JRPP No:	2011SYE095
DA No:	DA11/0834
LGA:	Sutherland Shire
Proposed Development:	Commercial Development - Construction of Neighbourhood Shopping Centre Comprising Woolworths Supermarket, Specialty Shops, Kiosk and Seven (7) Advertising Signs
Site/Street Address:	152 Old Illawarra Road, Barden Ridge (Lot 101 DP 1028645)
Applicant:	Fabcot Pty Ltd
Submissions:	25
Recommendation:	Refusal
Report By:	Evan Phillips– Environmental Assessment Officer (Planner) Sutherland Shire Council

Assessment Report and Recommendation

Figure 1: Site and Floor Plan of Proposal

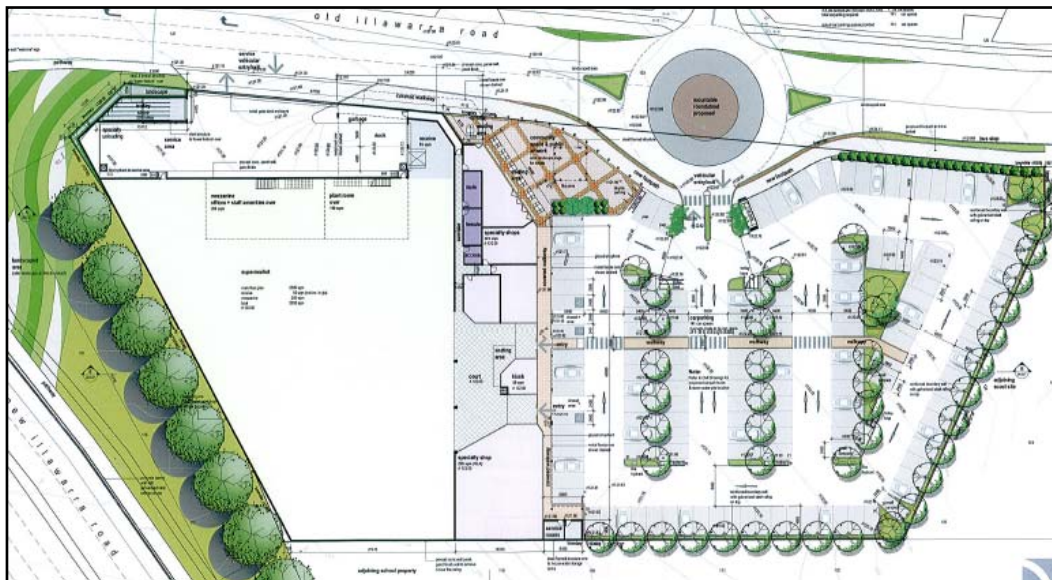
An application has been received for the construction of a neighbourhood shopping centre comprising a Woolworths' supermarket, specialty shops and advertising signage at the above property. The supermarket has an area of 2785m² with a mezzanine level and the specialty shops and kiosk have a total area of 530m². The plans indicate five (5) separate tenancies for the specialty shops. An 'on grade' parking area is located east of the building with 141 car parking spaces, with access from a proposed new roundabout at the intersection of Old Illawarra Road and Driscoll Place. The service, garbage and loading dock areas for commercial deliveries are located along the building's northern elevation directly fronting and accessed from Old Illawarra Road.

The main entry to this building is located towards the south-eastern corner of the building and is approximately 30 metres from the street access point. An open paved community space is proposed adjacent to Old Illawarra Road and three (3) large steel framed structures and associated signage works are proposed for the neighbourhood centre. The proposal entails the removal of all existing site vegetation and proposes landscape works predominantly within the eastern portion of the site and beyond the site boundaries in the adjoining road reserve to the north-west.
